Department of Transportation

MEMORANDUM

SUBJECT: ZC Case No. 21-20 – Stuart Buzzard Point (Phase 1)

Figure 1 | Site Plan

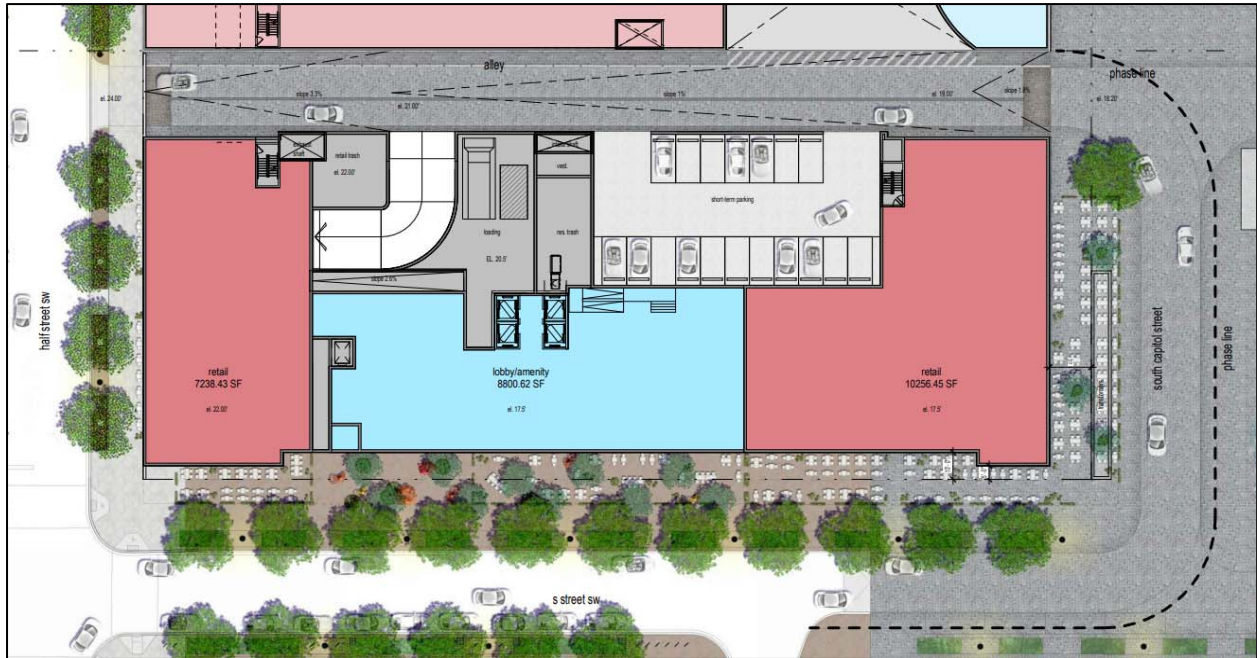
While the preliminary public space plans, shown in Figure 1, are generally consistent with DDOT standards, there are several considerations that need to be reviewed in greater detail during the public space permitting process:

- DDOT concurs that the existing curb cut on S Street SW should be closed and replaced with green space and street trees;
- An occupancy permit will be required for any portion of the outdoor dining areas in public space. Outdoor dining may not be located on top of utility vaults or transformers;

- An 8-foot pedestrian clear path should be maintained on all sidewalks surrounding the site;
- Specialty paving on S Street should be pulled back closer to the building and will need to be reviewed and approved by the Public Space Committee (PSC);

- Any paving or alternate driveway designs to be constructed within the remaining right-of-way of former S. Capitol Street must be reviewed and approved by the PSC;

- Identify a location on public or private property for one (1) Capital Bikeshare station;
- Identify final locations in public space for the short-term bicycle racks;

- Submit a Curbside Management Plan to refine curbside uses along South Capitol Street, S Street SW, and Half Street SW; and
- The curb cuts for the private alley should not exceed 24 feet in width. Curb cut apron should be of an alley design rather than a commercial curb cut.
